Quality Control Check Report. Stage: After Finishing Stage III (Apartments)

MAYFLOWER PLATINUM

Details of Additions & Alterations

Flat No	607	Block no.	'A'
Flat Area	1800 sft	Type	Deluxe / Luxury
Buyer Name	P Shailaja /Yanamandra Mahesh		
Phone No.	9989086492/9160496922	Email

WORKING DRAWING OF FLAT.NO.A-7

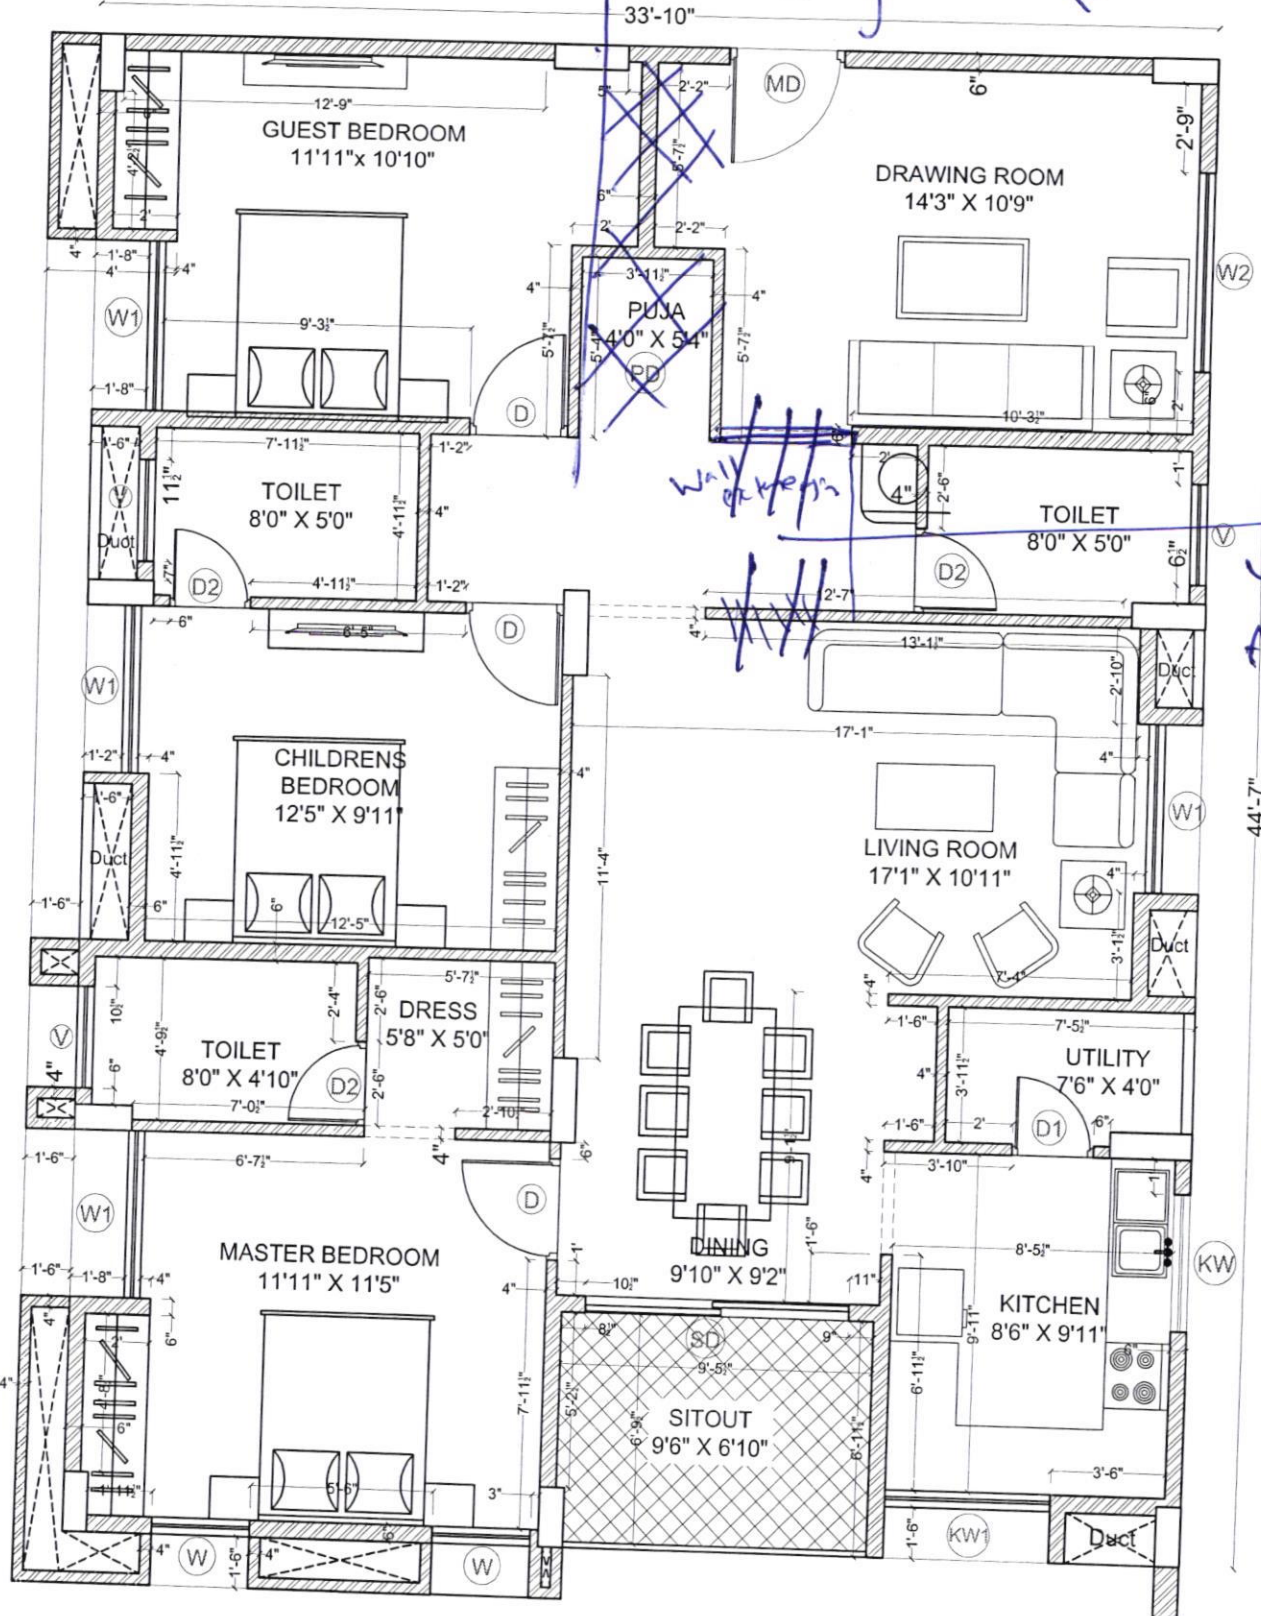
Wall corner

Remove
with
18/8/20

ELECTRICAL PLAN OF FLAT-A7

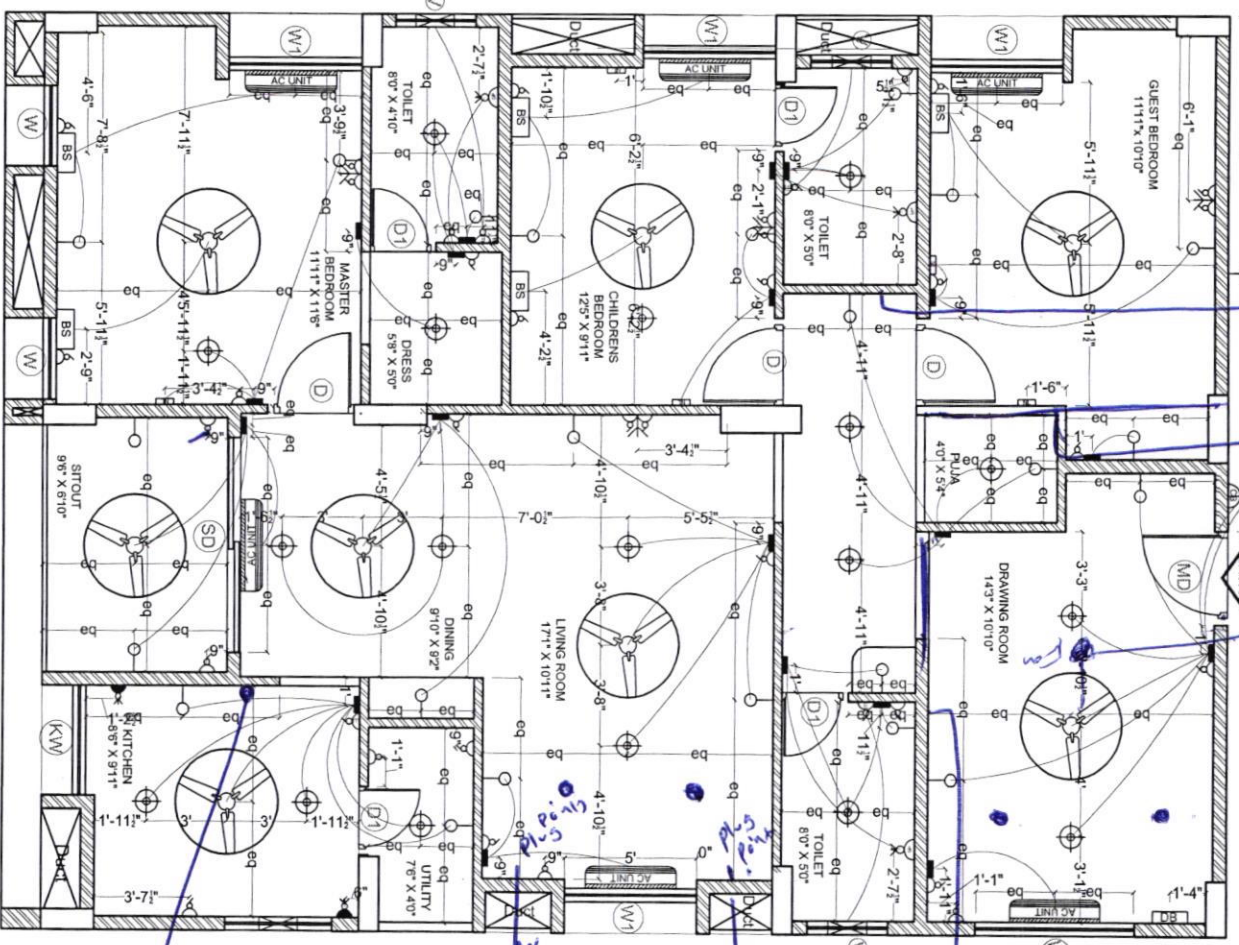
plus point
TV plus point
Iron hanging from ceiling
for swimming
TV plus point
Shah
12.4.11
12.4.11

Description	Direction	Owners & Developers :	Date	18.03.2020	Promoted by
WORKING DRAWING OF FLAT.NO.A-7		Modi Properties Pvt Ltd.	Prepared By :		Modi Properties Pvt. Ltd
		Project Name & Phase :	Approved By :	Soham Modi	Phone:+91-40-66335551
		MAYFLOWR PLATINUM	Scale :	N.T.S

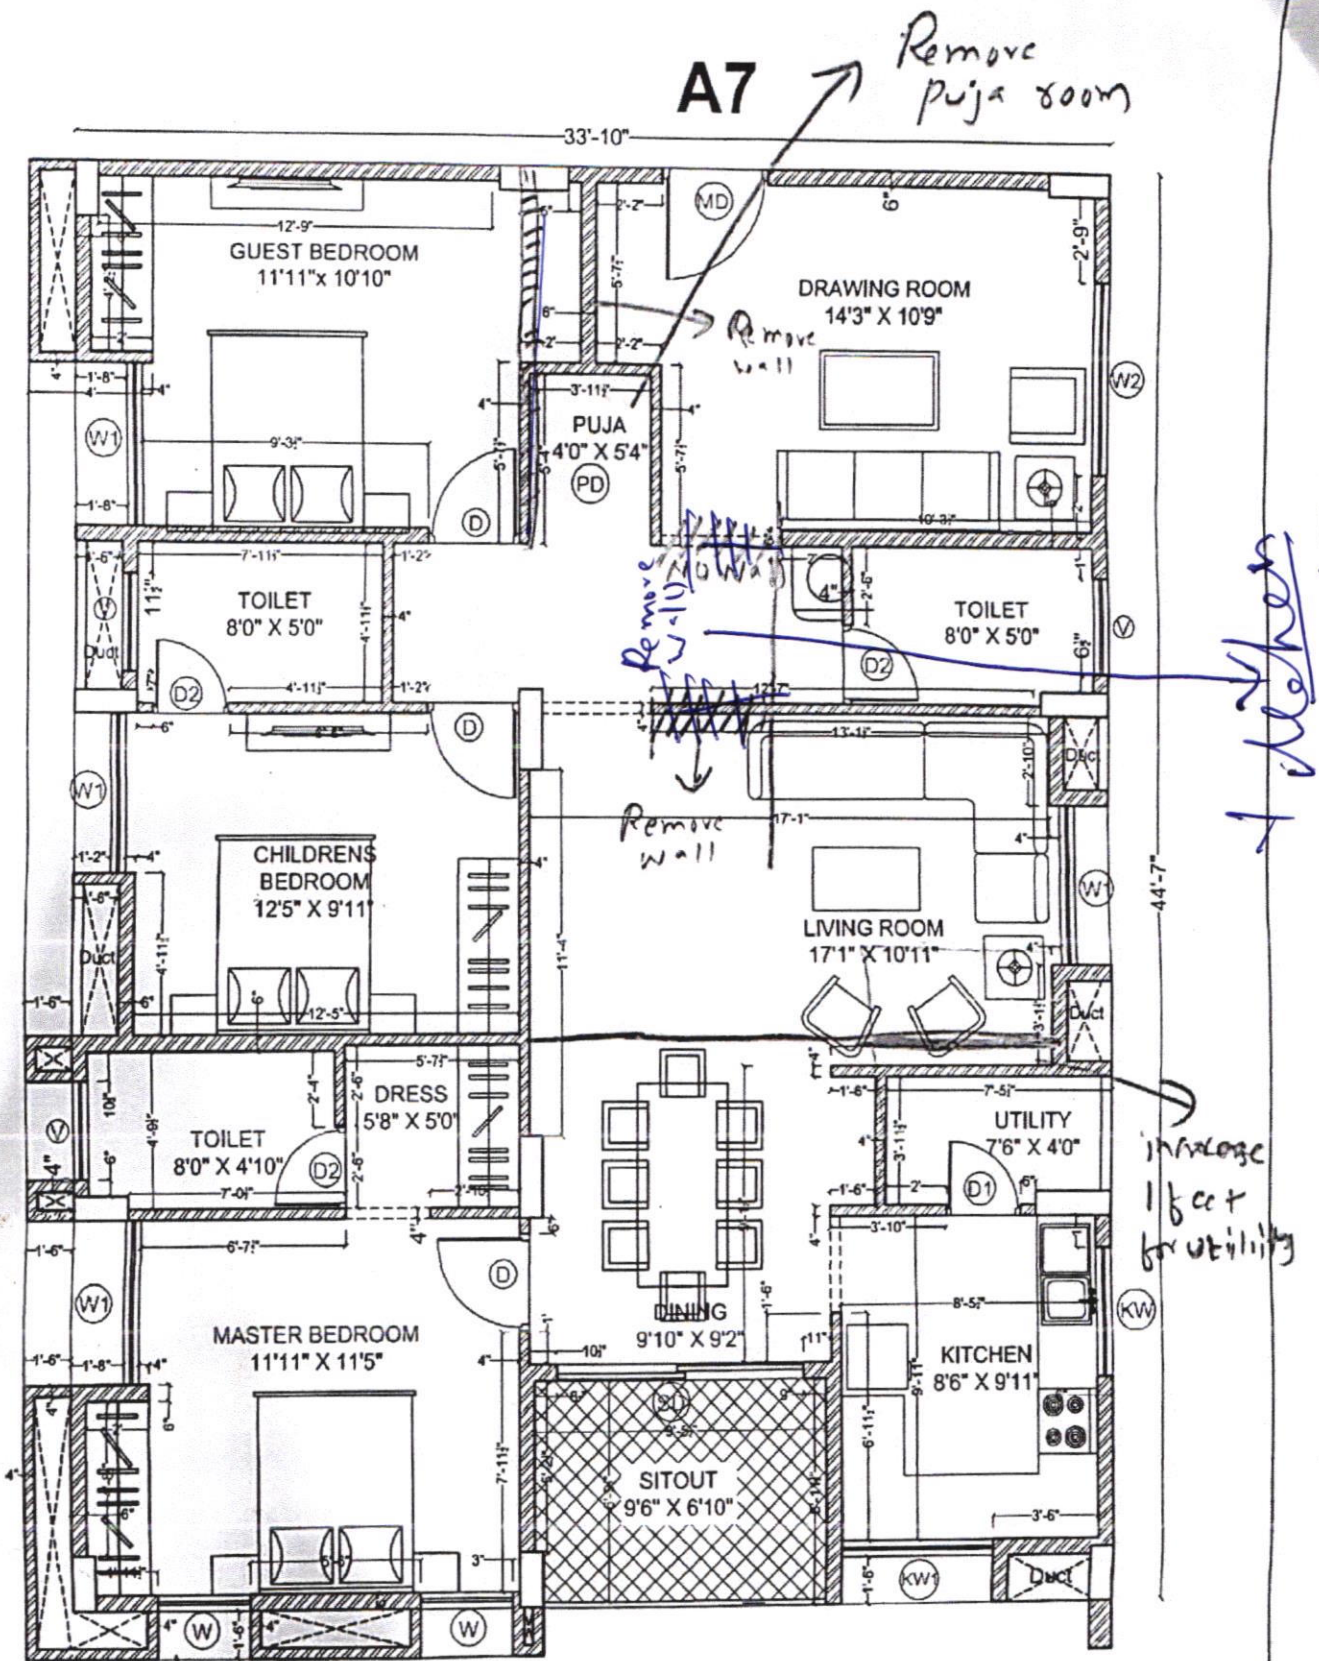
- Changes
- ① Remove Puja room
 - ② Don't extend bathroom walls (common)
 - ③ Increase Utility for 1 foot

Description	Direction	Owners & Developers :	Date :	Promoted by
PLUMBING PLAN OF A7	N	Modi Properties Pvt. Ltd.	09.01.2020	Modi Properties & Investments Pvt. Ltd.
		Project Name & Phase :	Prepared By :	Phone: +91-40-66335551
		Mayflower Platinum	Approved By : Sca	
			Soham Modi	
			N.T.S

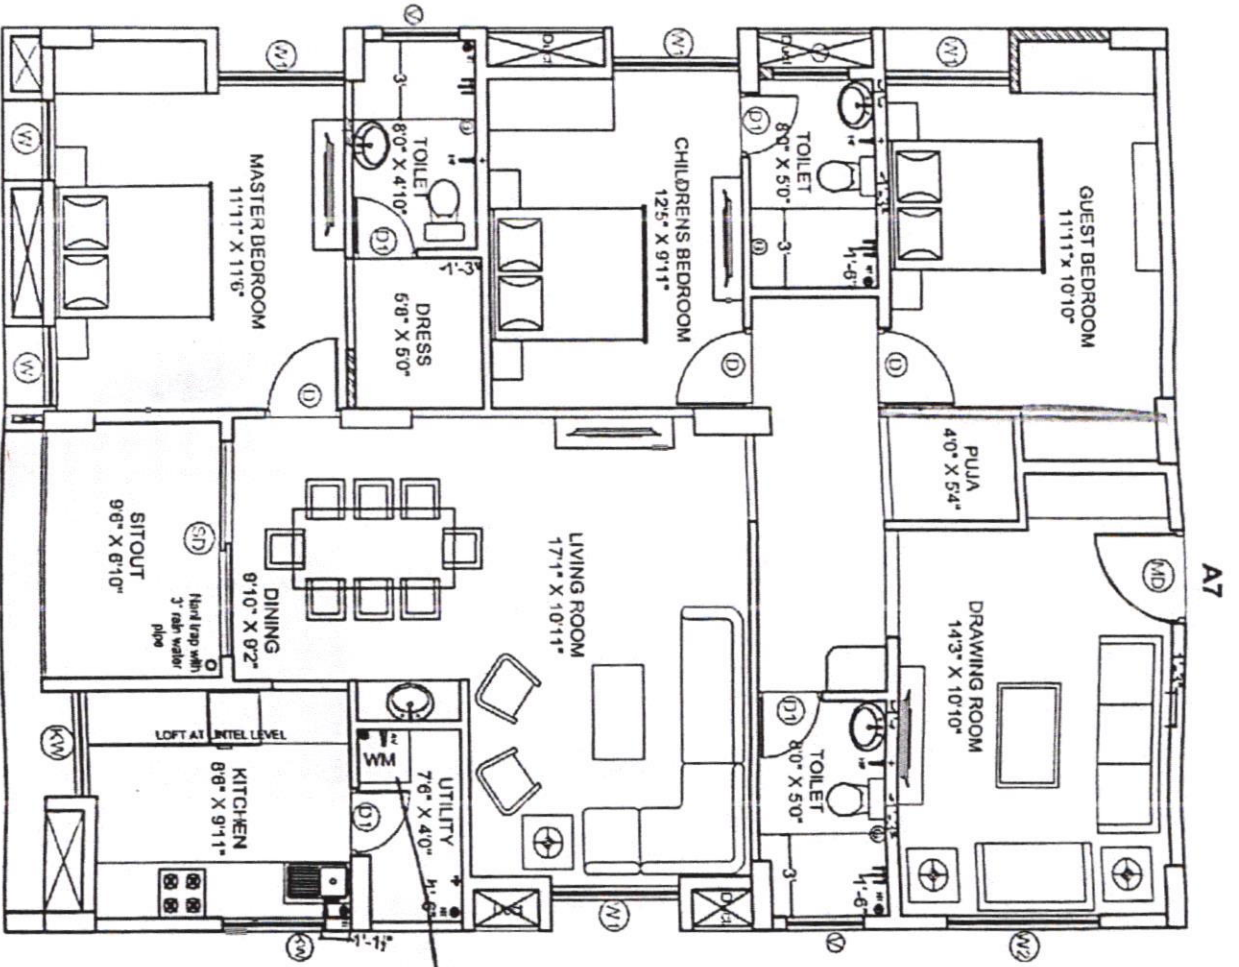
- ① White finishing - Walls
 - ② White color on - doors - door frames
 - ③ Three combinations in three bath-rooms
-

- ① White vitrified tile for all the rooms
We will provide (complete Apt)
-

- ① Exhaust fan hole in three bath rooms

Handwritten:
 Washing machine Bar

ELECTRICAL PLAN OF FLAT-A7

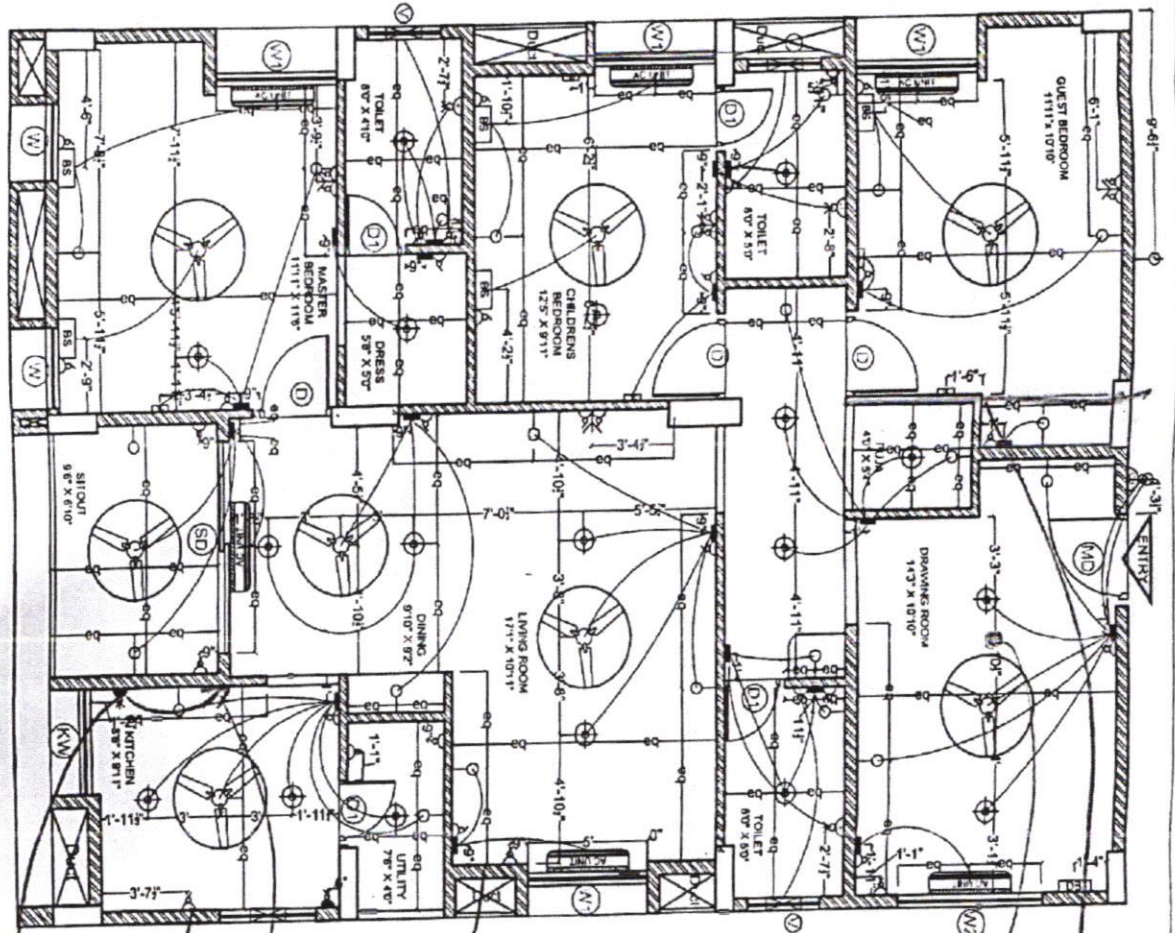
place change
Fridge plug place change
microwave mizi (grinder)
15amps switch point
plug point with switch with 15amps
Fan
TV + settop box + home theatre
plug + stabilizer
switch point
